IMPLEMENTATION WORK PLAN
CENTREDALE MANOR RESTORATION SUPERFUND SITE
NORTH PROVIDENCE, RHODE ISLAND

August 6, 2001

LOUREIRO ENGINEERING ASSOCIATES, INC.
100 Northwest Drive
Plainville, Connecticut

Comm.No.	FIGURE 1–1	LEA
15RP101.001

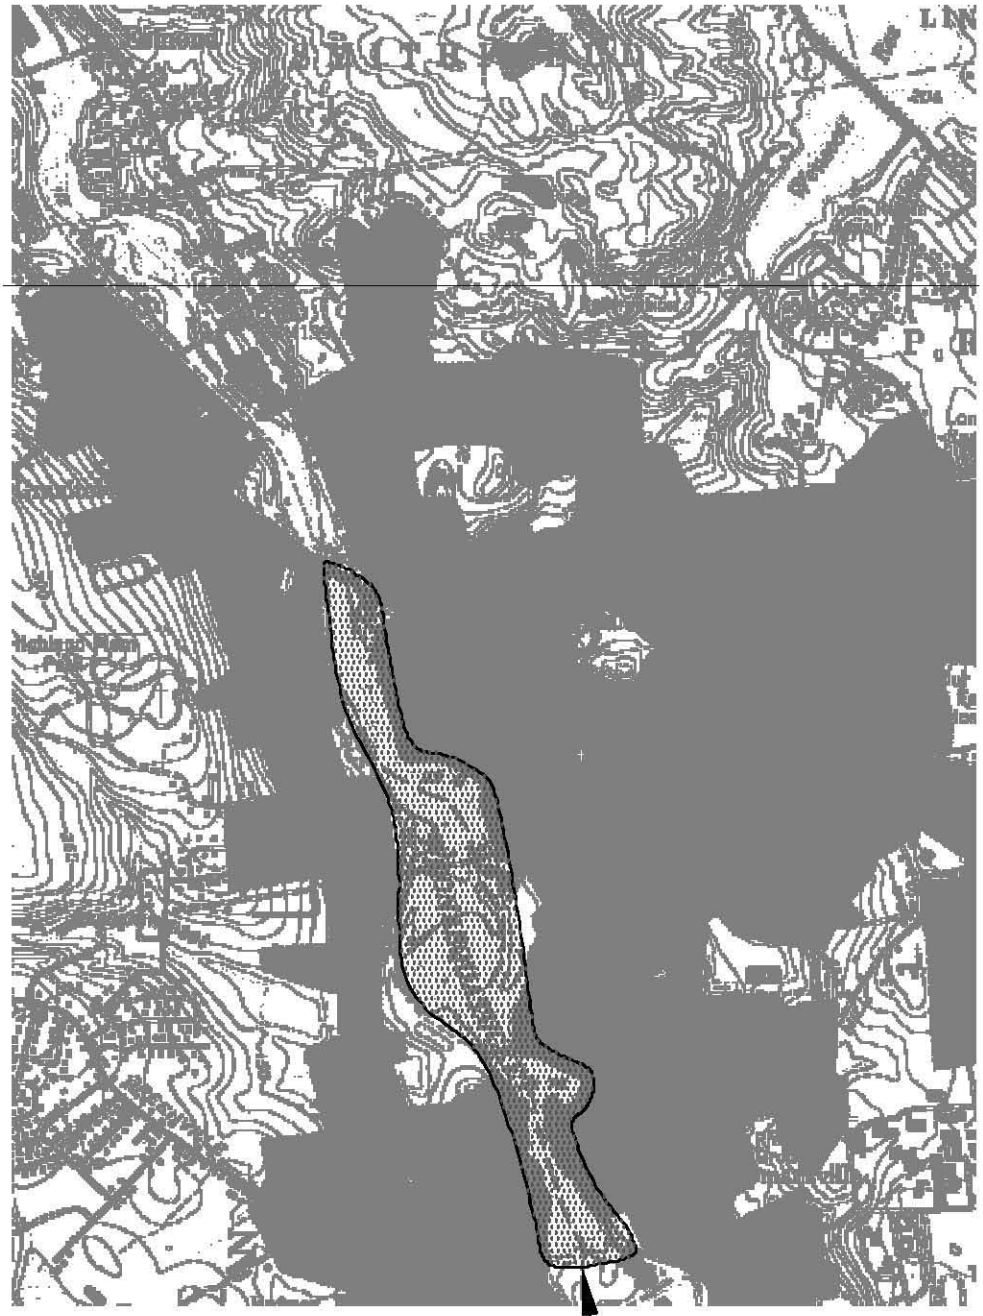
1. **Fig. 1-1, the site location should show general location of office and storage area. The map scale is too small and is hard to read.**

The Site Location Map provided as Figure 1-1 is intended only for identifying the site in respect to major roadways and surrounding neighborhoods. It is not intended to provide any details for locations of areas at the site. The storage area location can be found on Figure 3-1.

FIGURE 4–1

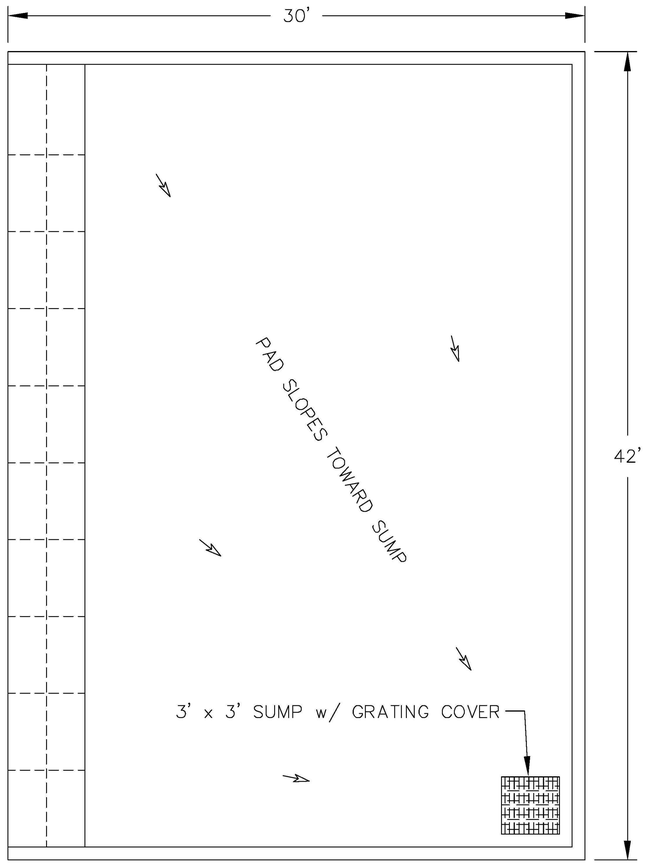
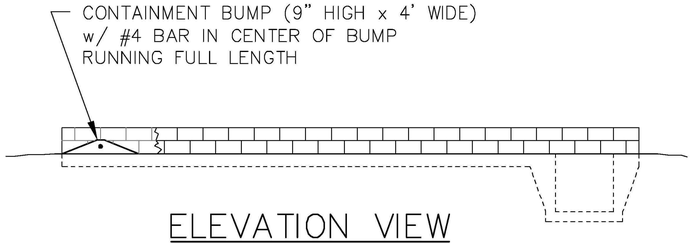
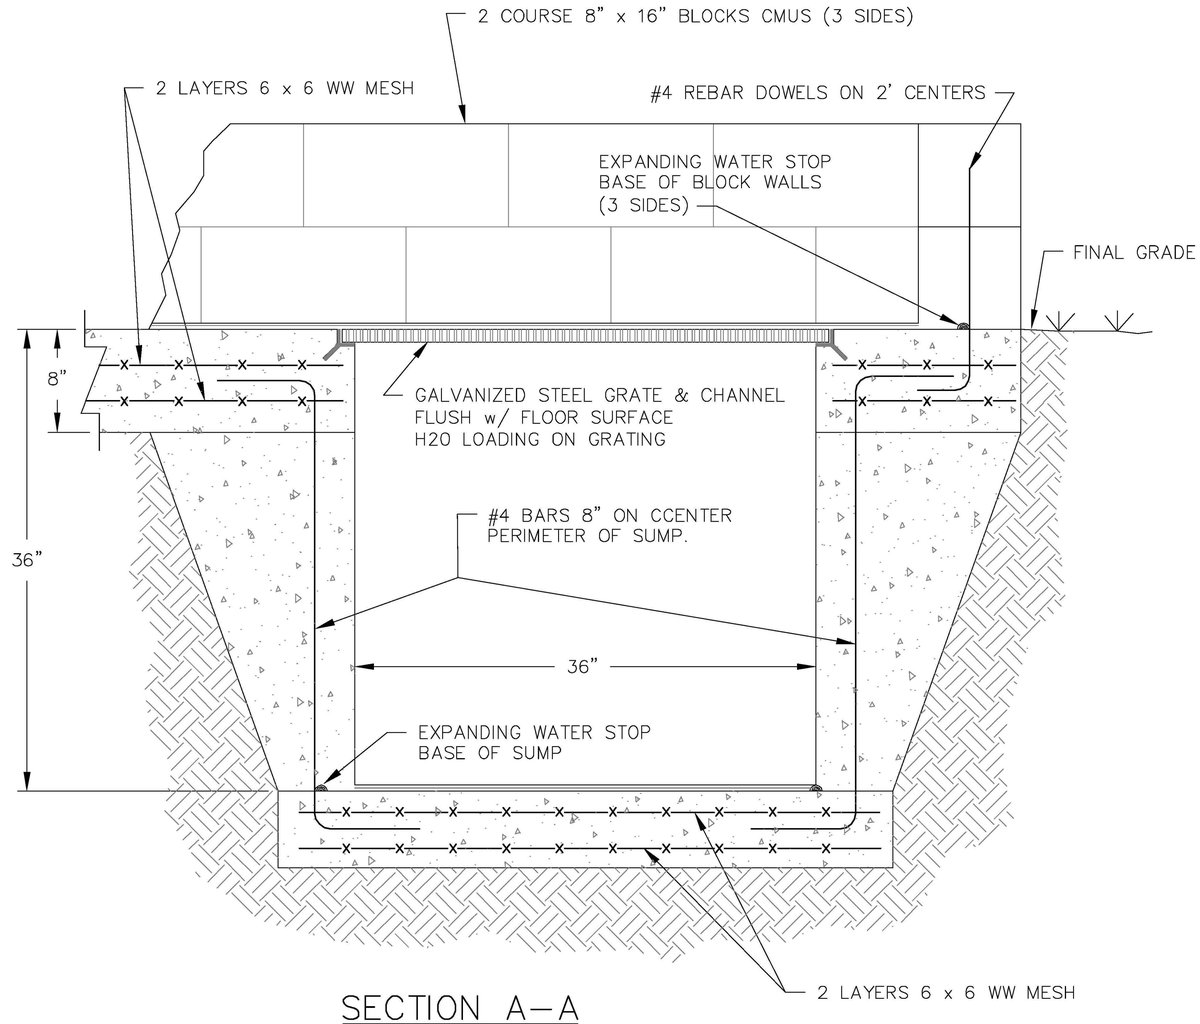
8. **Pg. 4-3 §4.2.1 &Figure 4-1 What is the slope of the containment pad (1%, 2%,…)? Additionally, what is the total volume allowed to be stored within this containment pad? Per 40CFR 264.175 (b)(3) the containment system must have sufficient capacity to contain 10% of the volume of the volume of the containers or the volume of the largest container, whichever is greater. However, this is dependent upon the amount of free liquid stored on this pad. Please provide calculation and additional information to clarify that his does meet the CFR.**

4. **Fig. 4-1 – Does this figure describe Action Area 8 construction or for other areas too?**

A note will be placed on the Figure 4-1 that identifies the slope of the concrete slab at 2% to the sump in the corner of the containment pad.
